**DOCUMENT 00 91 03  
ADDENDUM NO. 3**

PROJECT: 2024 Smith and Spillane MS Renovations  
BID DATE: **Thursday, February 20, 2025 (no Change)**  
FROM: Carolina Weitzman, A.I.A.  
Natex Corporation Architects  
447 Heights Blvd, Houston, TX 77007  
TO: **Prospective Bidders**

**PLUMBING SITE PLAN**  
**P1.03**

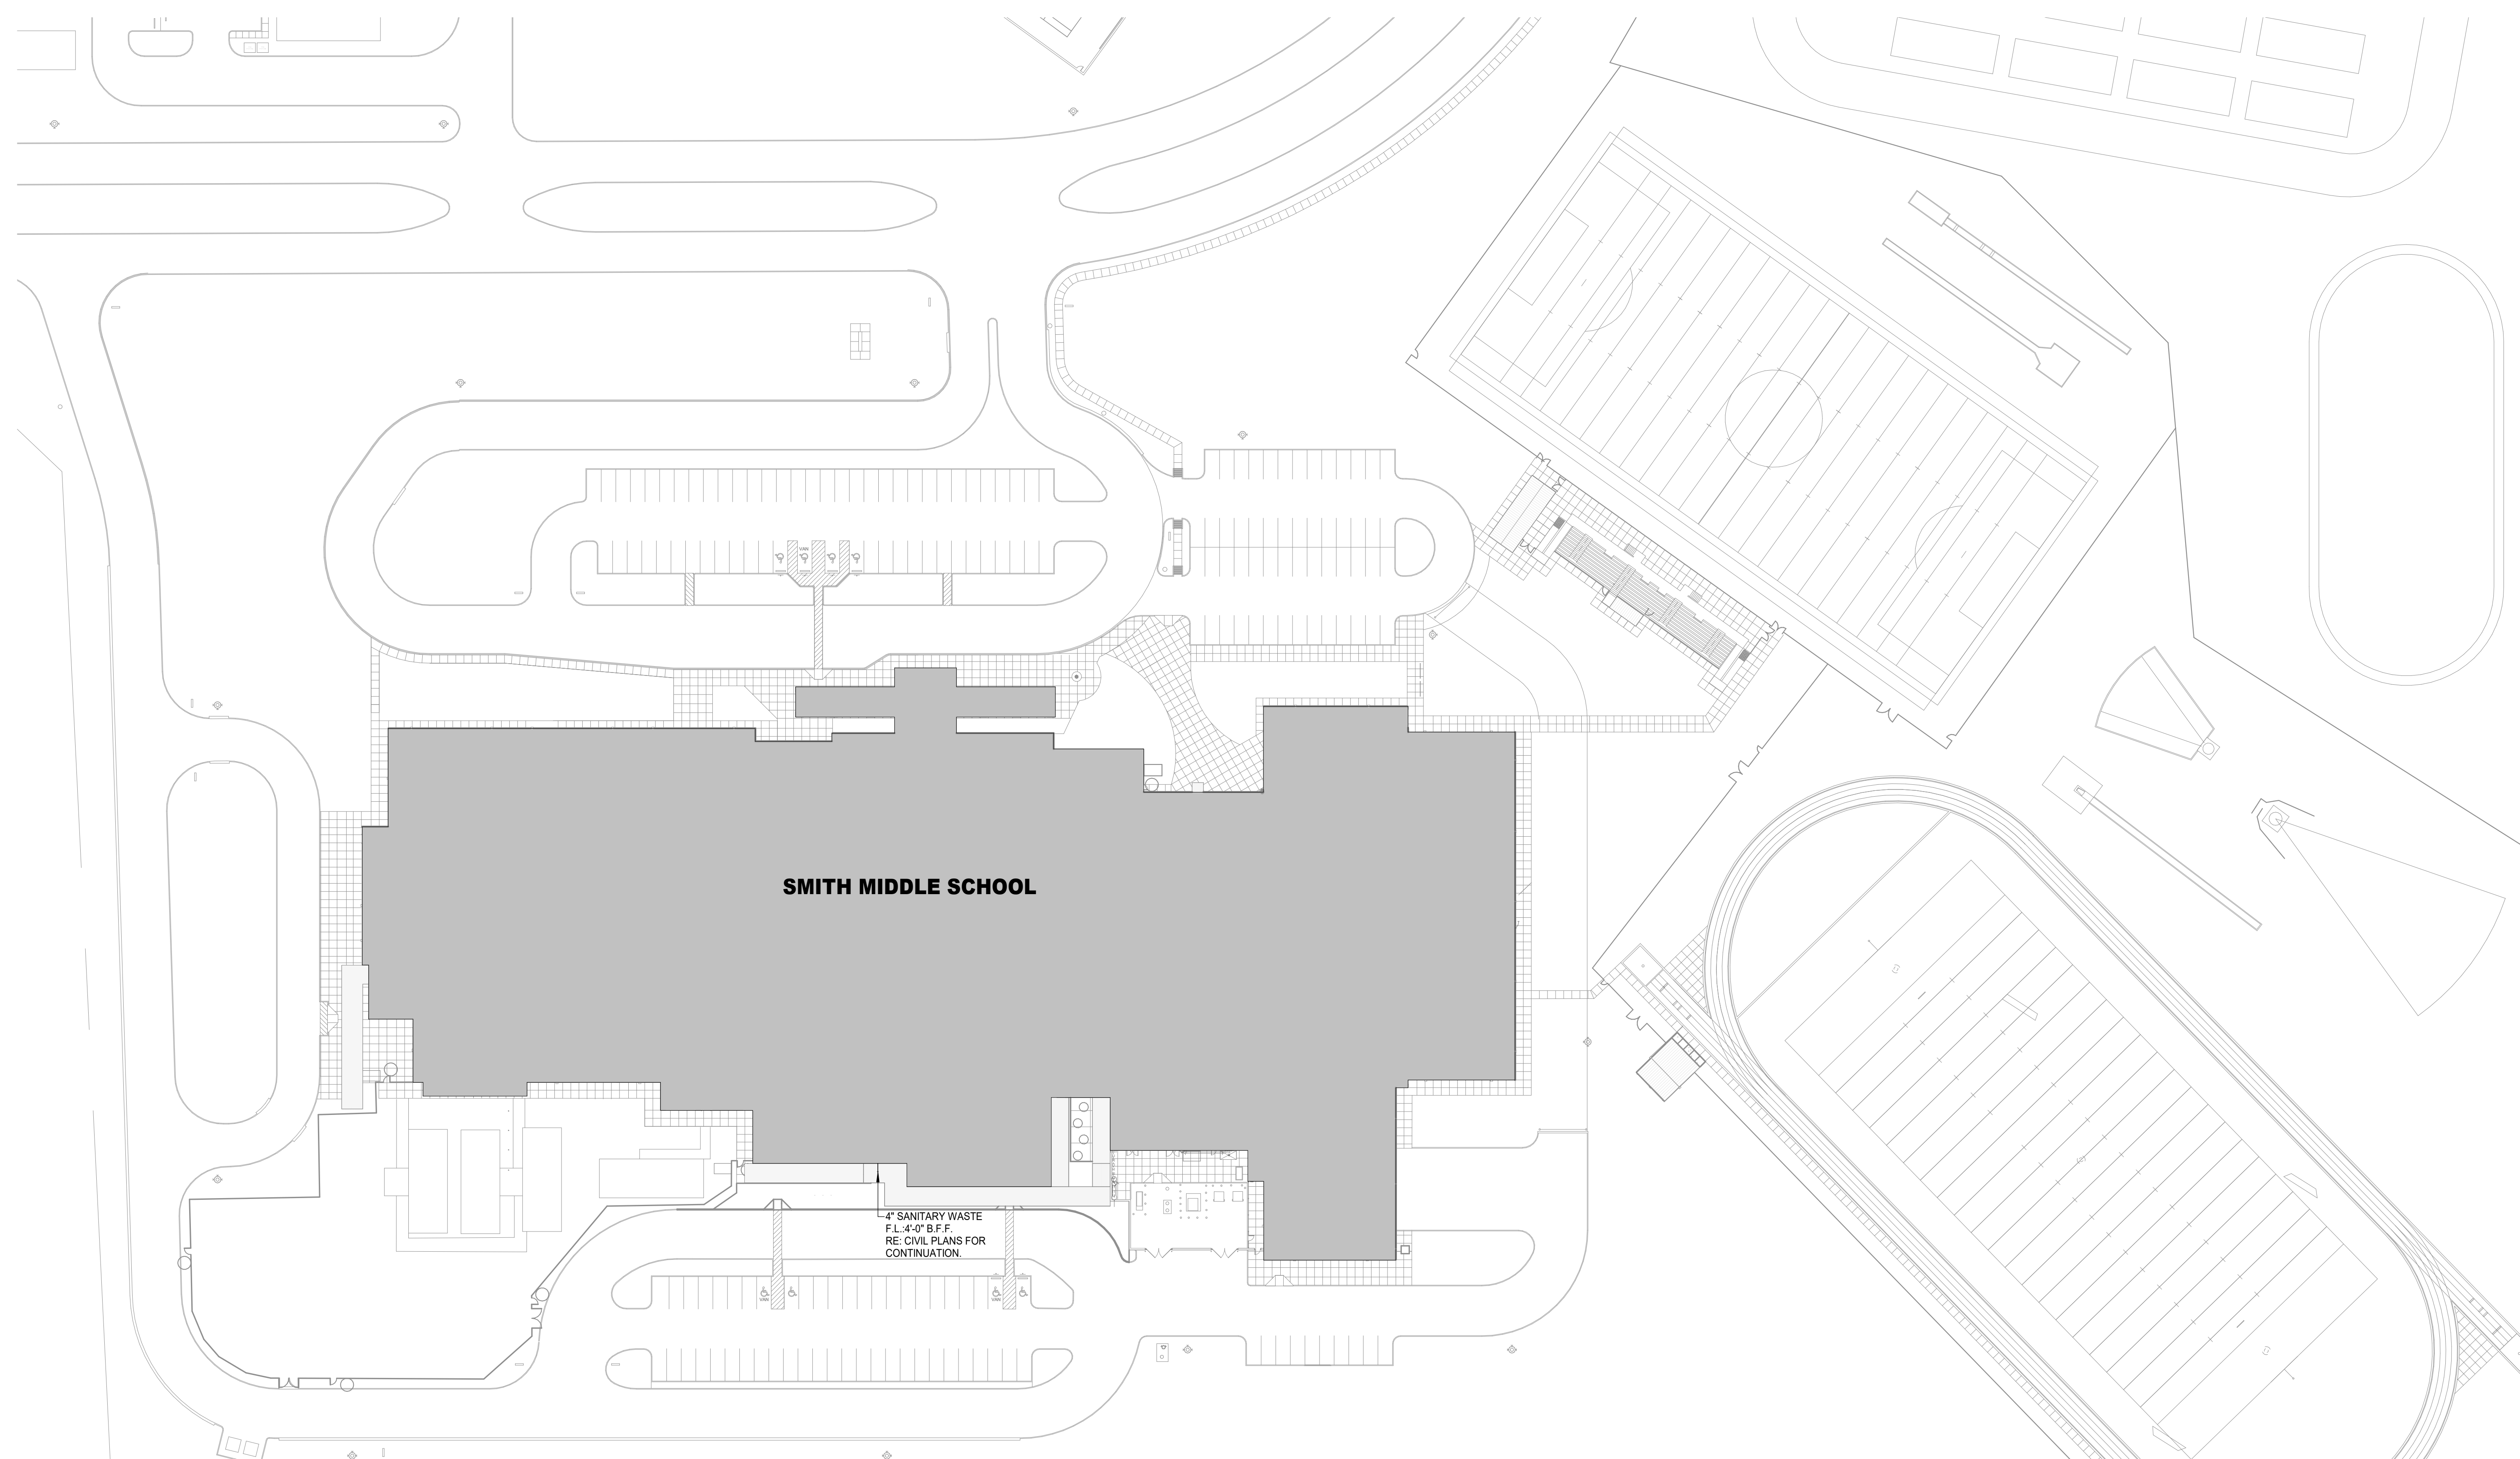
- a. Power provided for new Kiln EF-1.
16. P1.03 – PLUMBING SITE PLAN
  - a. Refer to attached new sheet for new site sanitary connection.
17. T0.00 – TECHNOLOGY NOTES AND LEGENDS

Project Number: 23073  
 Date: 26 JANUARY 2025  
 Drawn By: WHL / KLO  
**TECHNOLOGY COMPOSITE 2ND FLOOR PLAN**  
**T1.03**

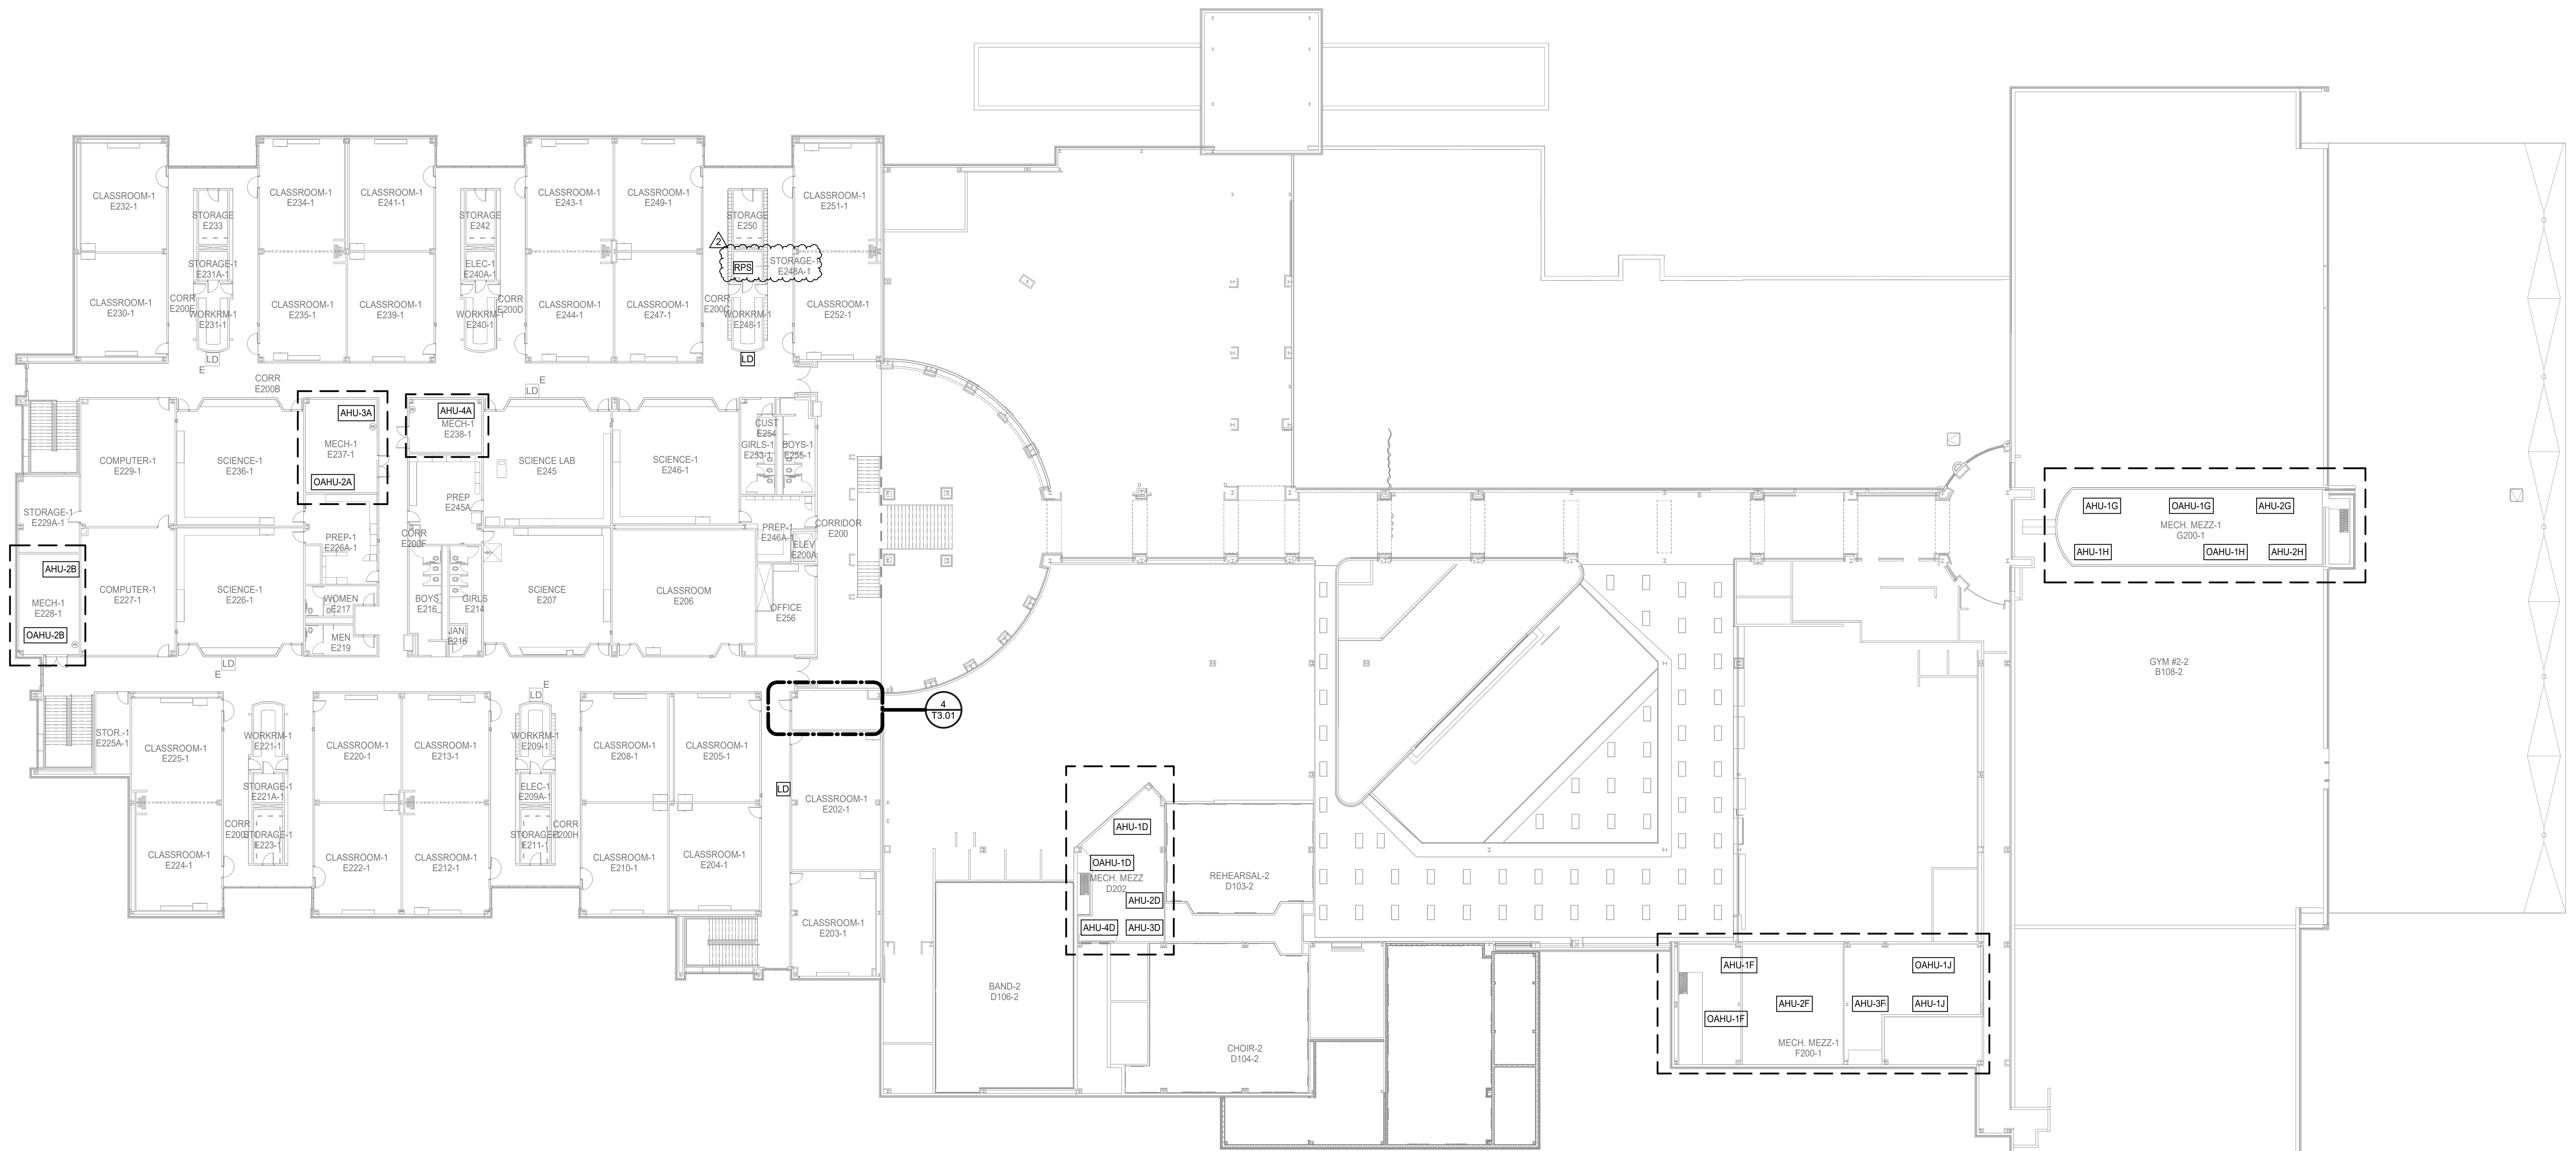
19. T1.03 – TECHNOLOGY COMPOSITE 2<sup>ND</sup> FLOOR PLAN
  - a. Refer to revised plan for fire alarm remote power supply locations.
20. T2.11 – TECHNOLOGY SECOND FLOOR PLAN – AREA 'B'

**TECHNOLOGY SECOND FLOOR PLAN - AREA 'B'**  
**T2.11**  
 of

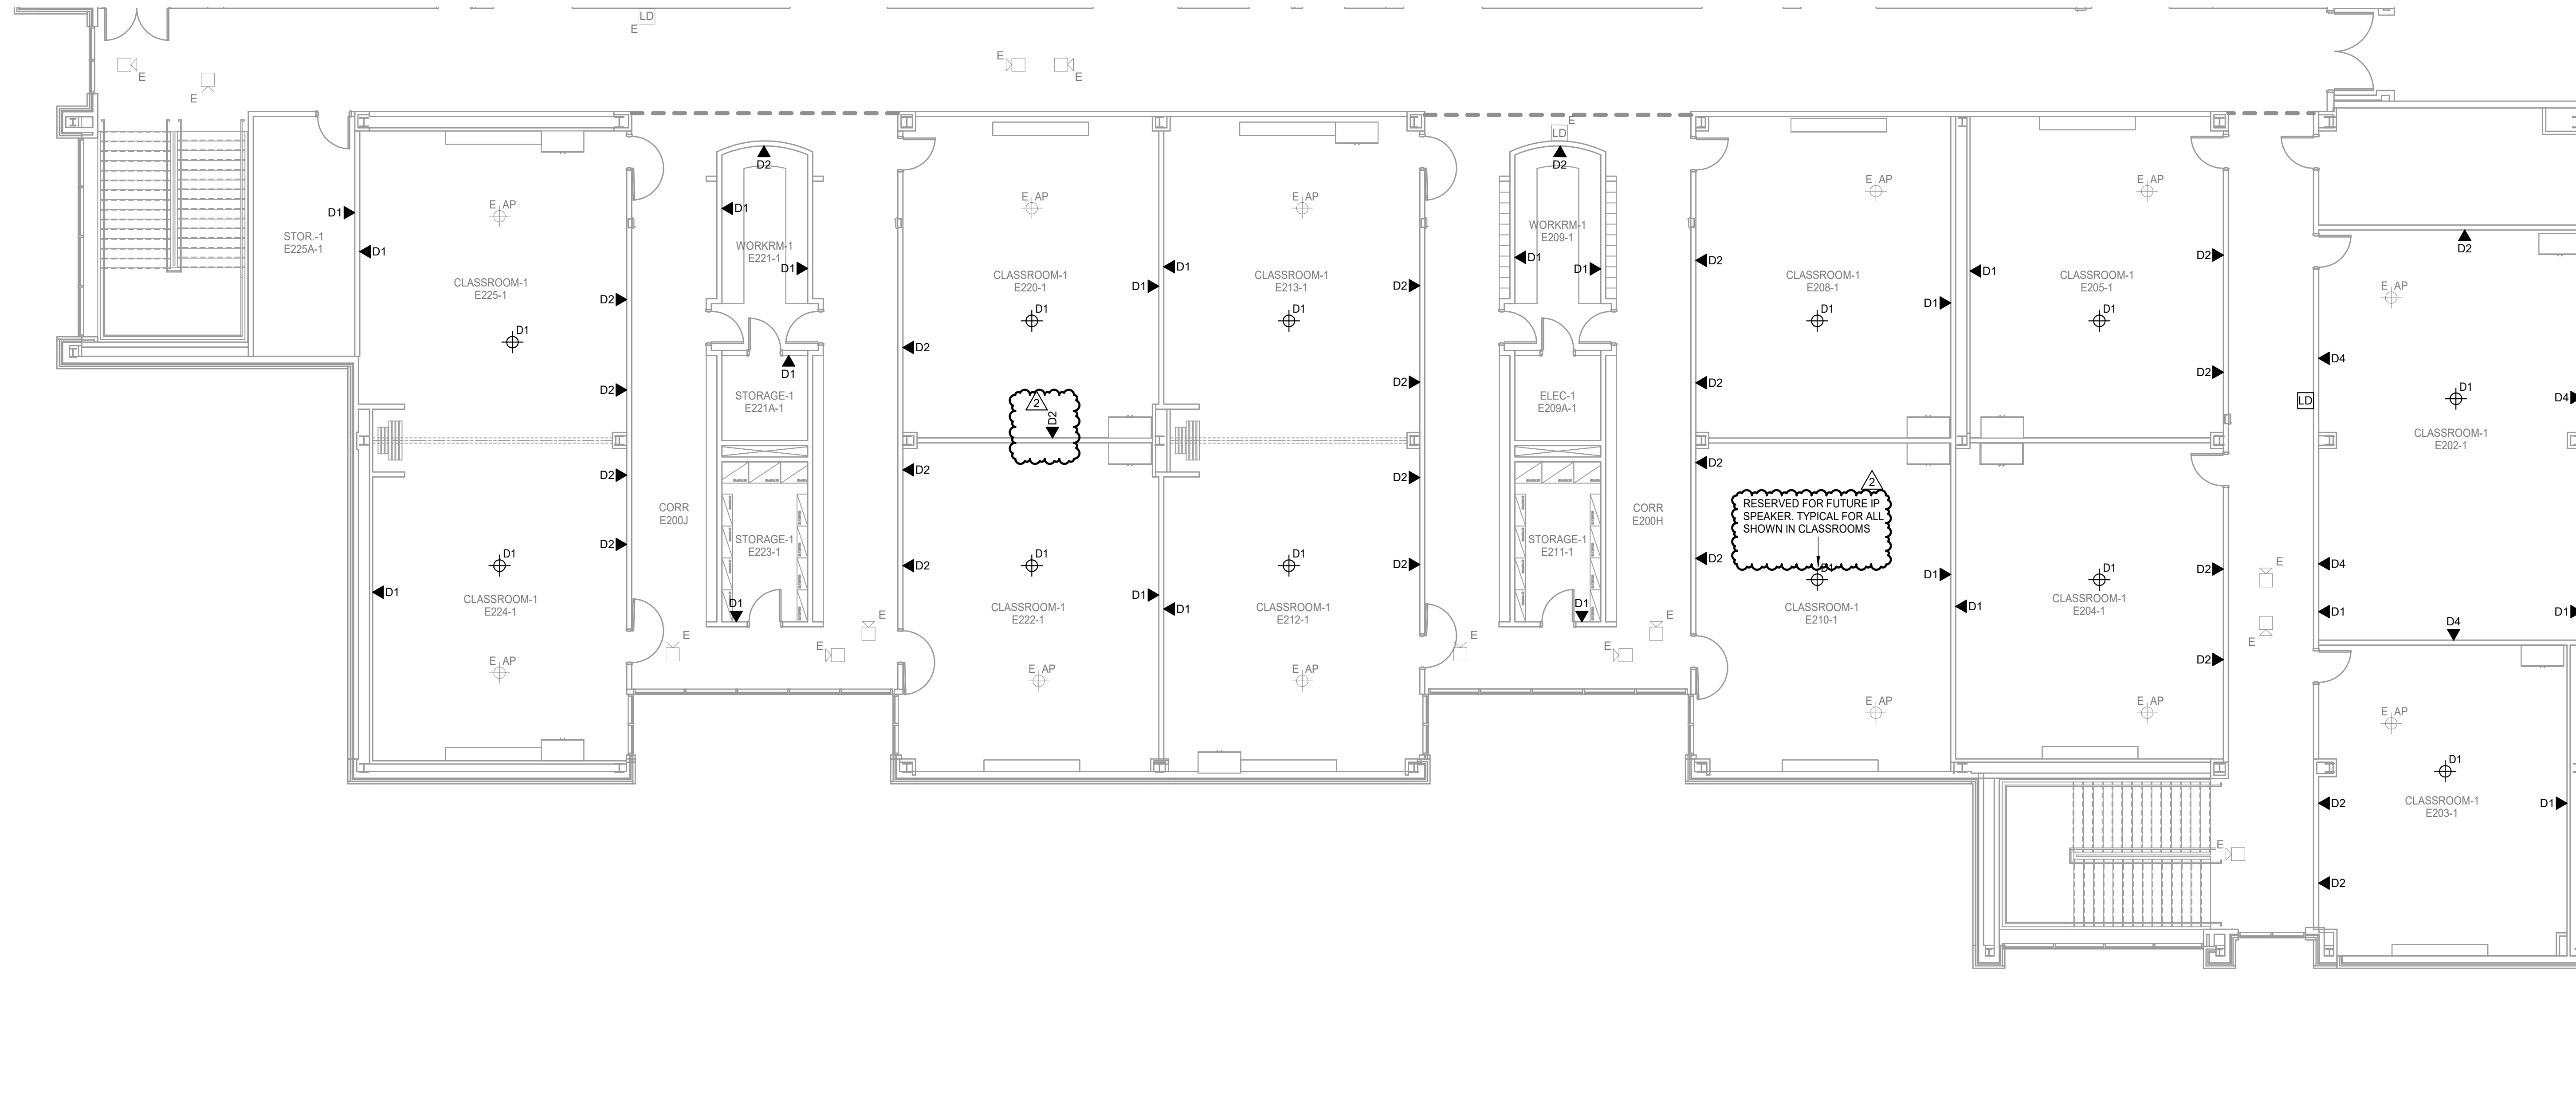
- a. Refer to revised plan for additional drop location and ceiling drop clarification.
